**STATE OF HAWAII
DEPARTMENT OF TRANSPORTATION
HIGHWAYS**

**ADDENDUM NO. 2
FOR
KUHIO HIGHWAY RESURFACING
WAIKAEA BRIDGE TO MAILIHUNA ROAD
FEDERAL-AID PROJECT NO. NH-056-1(063)
DISTRICT OF KAWAIHAU
ISLAND OF KAUAI
April 27, 2023**

This Addendum makes the following amendments to the Bid Documents:

RECTANGULAR RAPID FLASHING BEACON WITH OVERHEAD LIGHT
Not To Scale

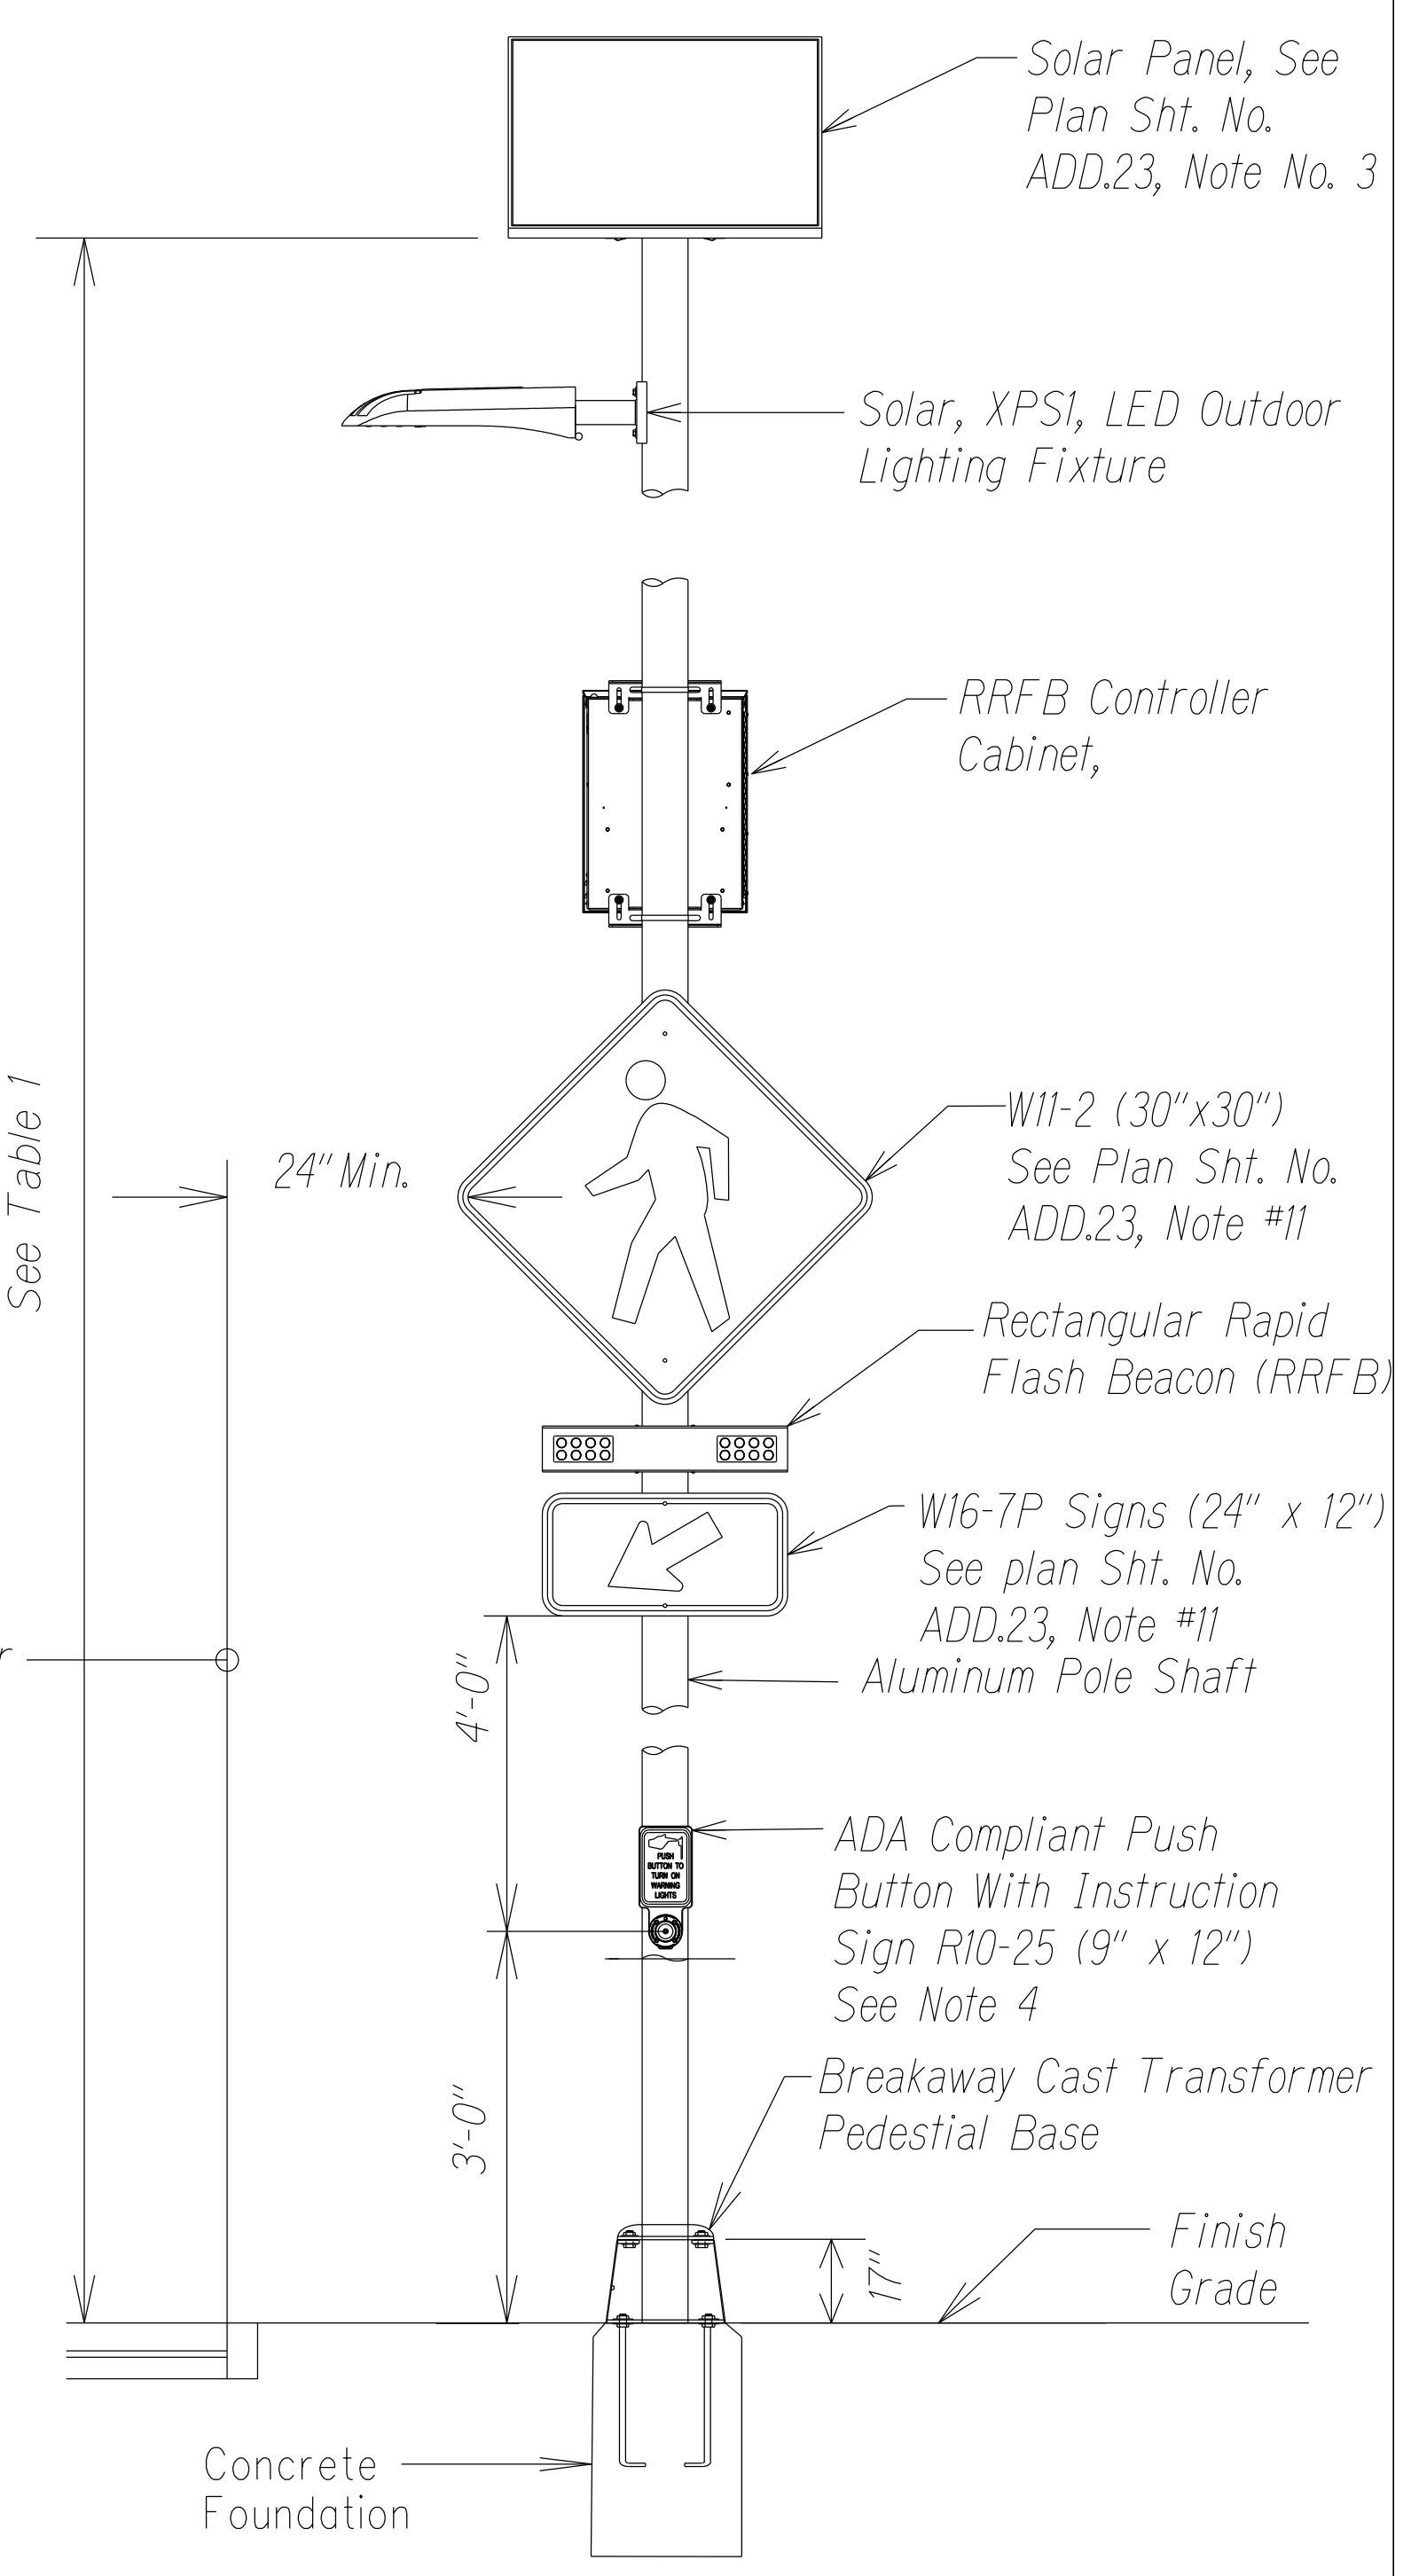
33. Is there a brand or type of break-away pedestal base that is required for the Rectangular Rapid Flashing Beacon? Can a detail of the break-away base be provided?

RESPONSE: See addendum 2 for added detail.

FED. ROAD DIST. NO.	STATE	FED. AID PROJ. NO.	FISCAL YEAR	SHEET NO.	TOTAL SHEETS
HAWAII	HAW.	NH-056-1(063)	2023	ADD.31	43

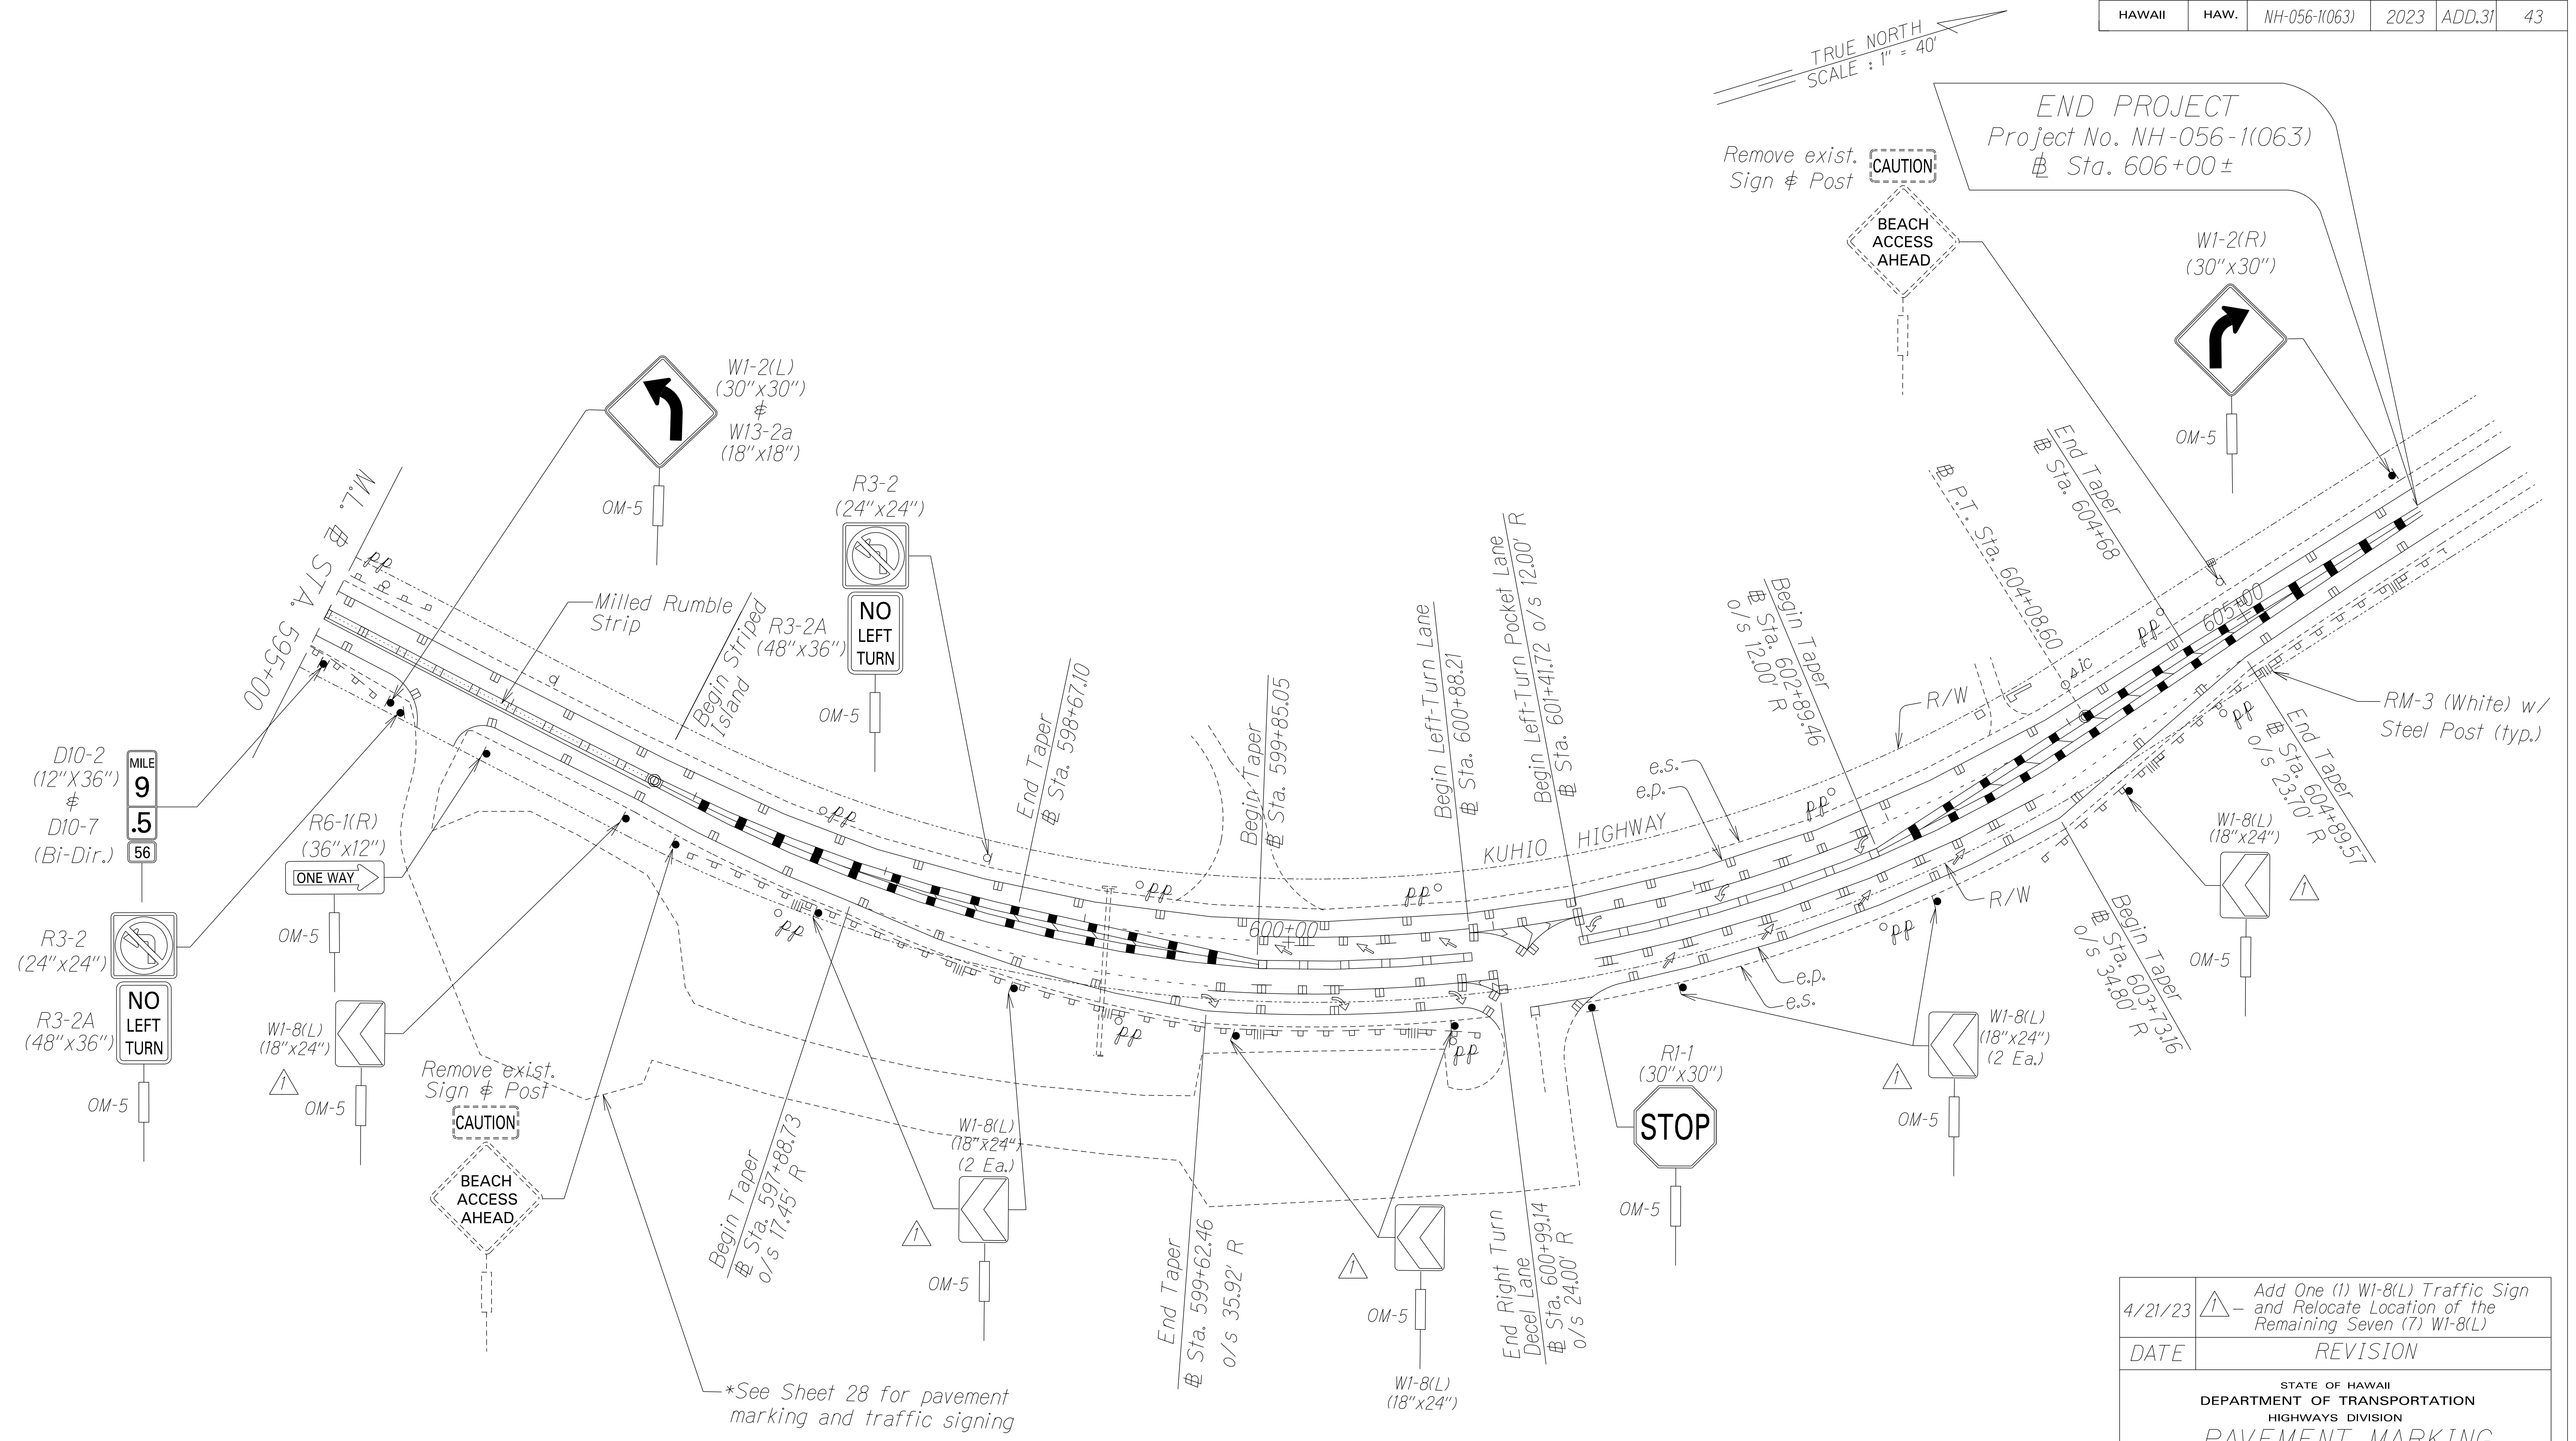
4/21/23	△ - Add One (1) W1-8(L) Traffic Sign and Relocate Location of the Remaining Seven (7) W1-8(L)
DATE	REVISION
STATE OF HAWAII DEPARTMENT OF TRANSPORTATION HIGHWAYS DIVISION PAVEMENT MARKING & TRAFFIC SIGNING PLAN <u>KUHIO HIGHWAY RESURFACING</u> <u>Waikaea Bridge to Mailihuna Road</u> <u>Federal-Aid Project No. NH-056-1(063)</u> Scale: 1" = 40' Date: April 2023	
SHEET No. 5 OF 6 SHEETS

FED. ROAD DIST. NO.	STATE	FED. AID PROJ. NO.	FISCAL YEAR	SHEET NO.	TOTAL SHEETS
HAWAII	HAW.	NH-056-110631	2023	ADD.32	43

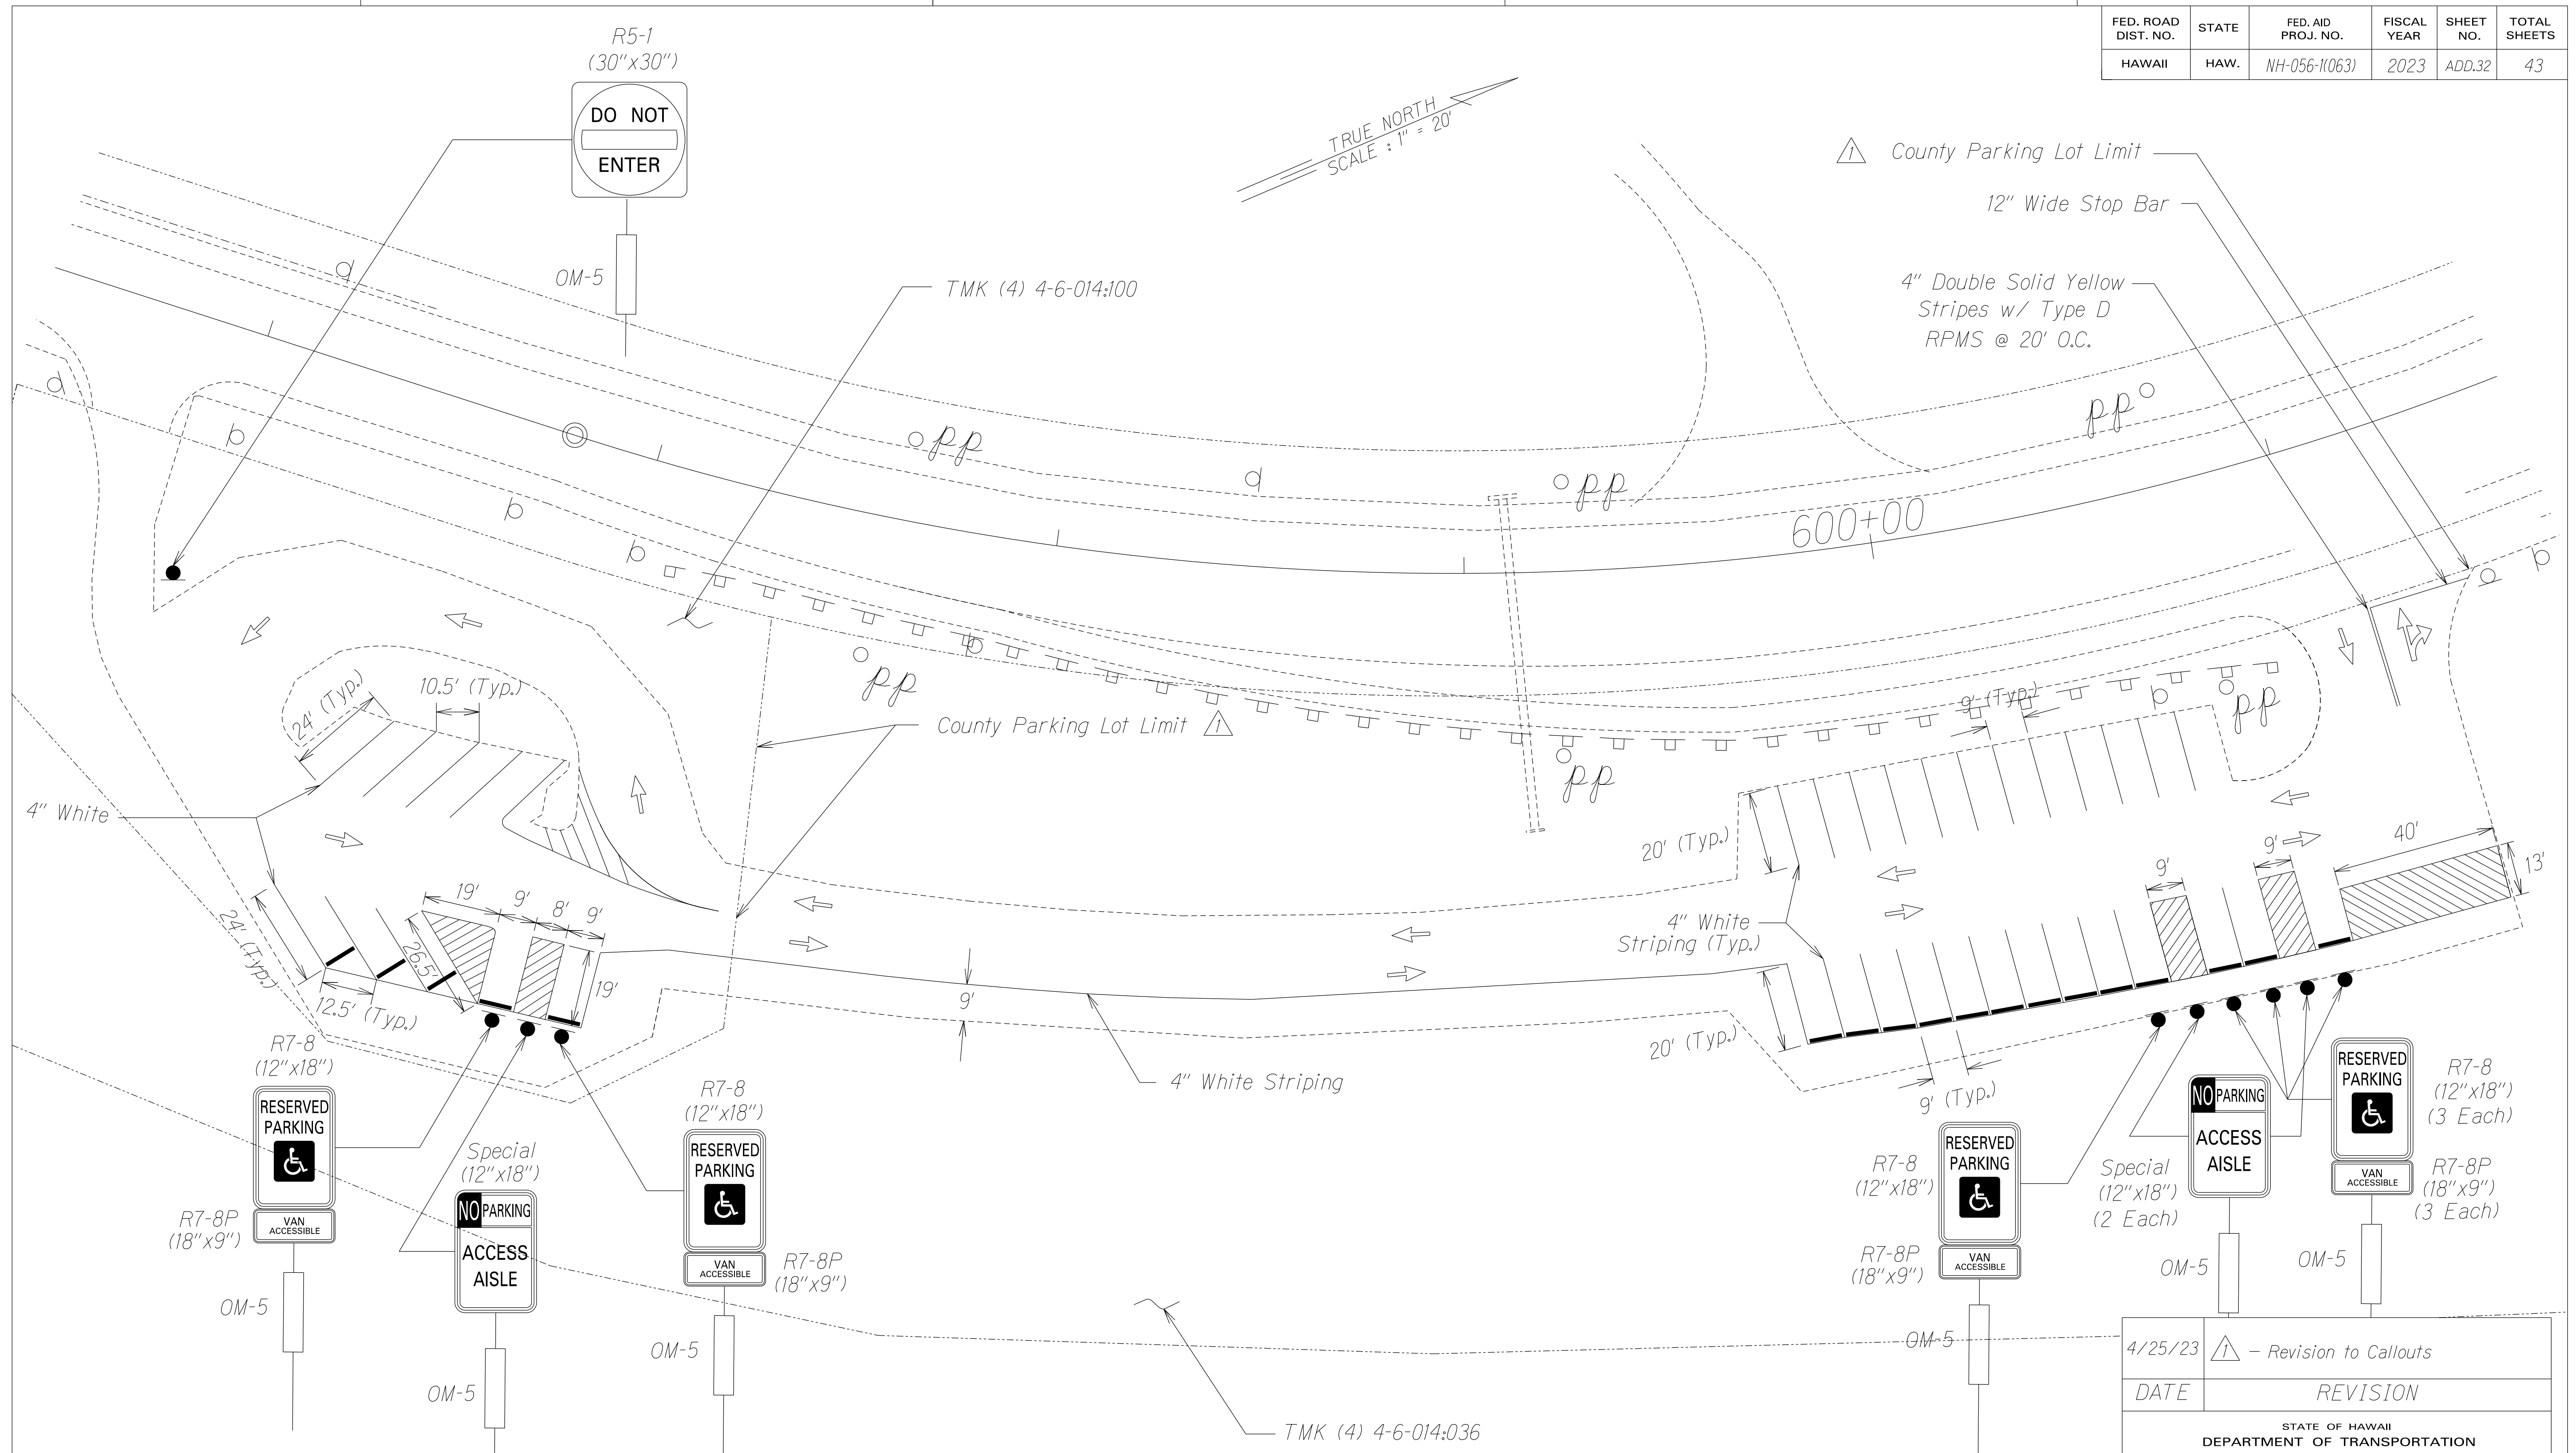
4/25/23	△ - Revision to Callouts
DATE	REVISION
STATE OF HAWAII DEPARTMENT OF TRANSPORTATION HIGHWAYS DIVISION PAVEMENT MARKING & TRAFFIC SIGNING PLAN <u>KUHIO HIGHWAY RESURFACING</u> <u>Waikaea Bridge to Mailihuna Road</u> <u>Federal-Aid Project No. NH-056-110631</u> Scale: 1" = 20' Date: Mar. 2023	
SHEET No. 6 OF 6 SHEETS
